**CERTIFICATE OF APPROPRIATENESS**

**Applicant:** John Morrison, John Morrison Architect, for Patrick Sinclair, owner

**Property:** 721 Cortlandt Street, Lot 7, Block 259, Houston Heights Subdivision. The property includes a 1,989 square foot, one-story wood frame single-family residence and detached two-story garage structure situated on a 6,600 square foot (50' x 132') interior lot.

**Proposal:** Alteration – Remove existing cladding and fenestration materials and replace with new, more specifically:

EAST ELEVATION – FRONT FACING CORTLANDT STREET

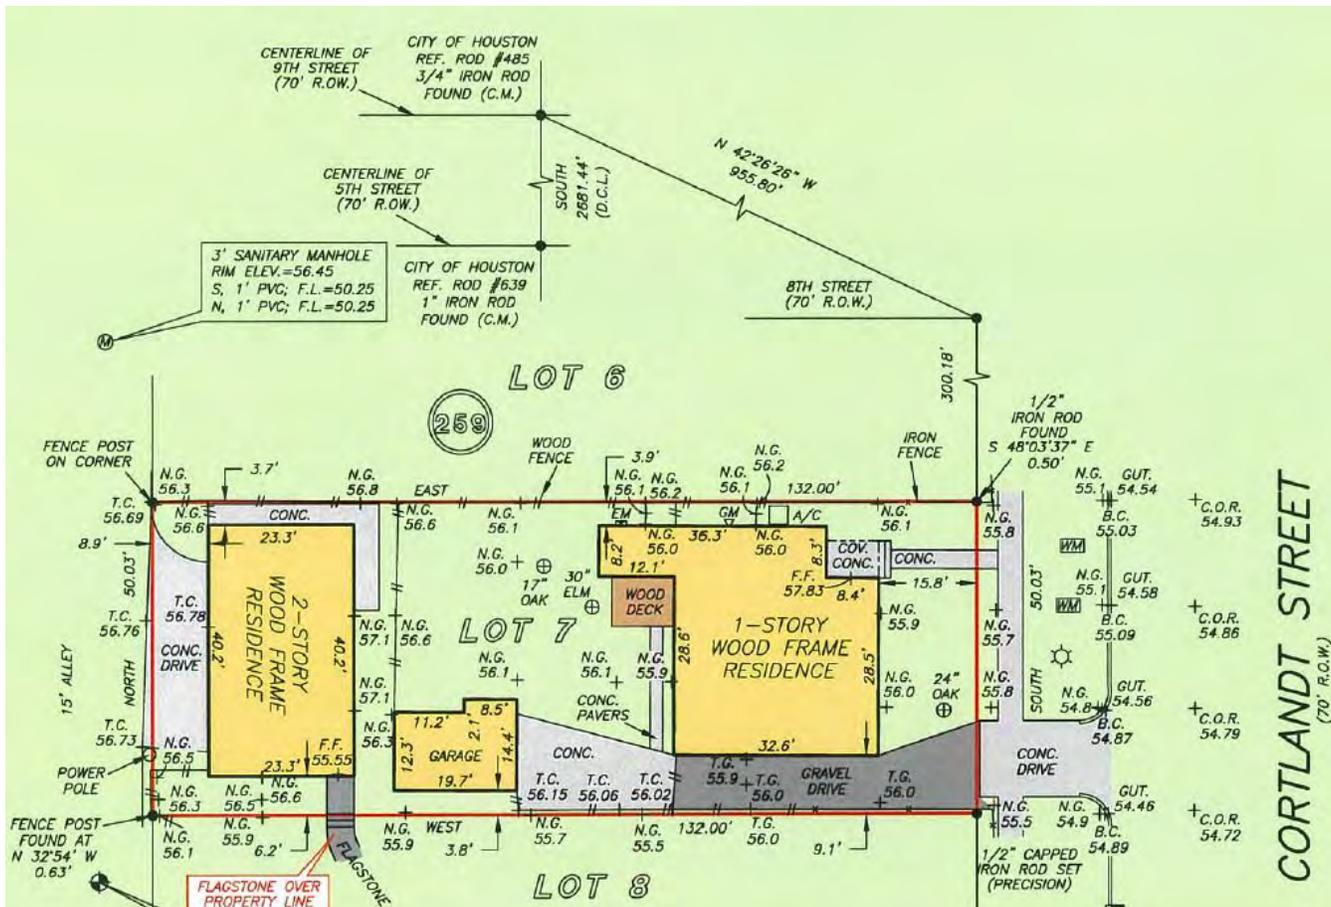
Agenda Item #32 - 721 Cortlandt – I **support** this request for a CofA for this non-contributing structure. I recommend consideration be given to slightly smaller windows on the street elevation to provide a more-appropriate wall-space-to-window-space scale for the smaller structure façade but there is an appreciation for an attempt to bring a non-contributing structure in closer context with historical elements of contributing structures in the HHSHD.
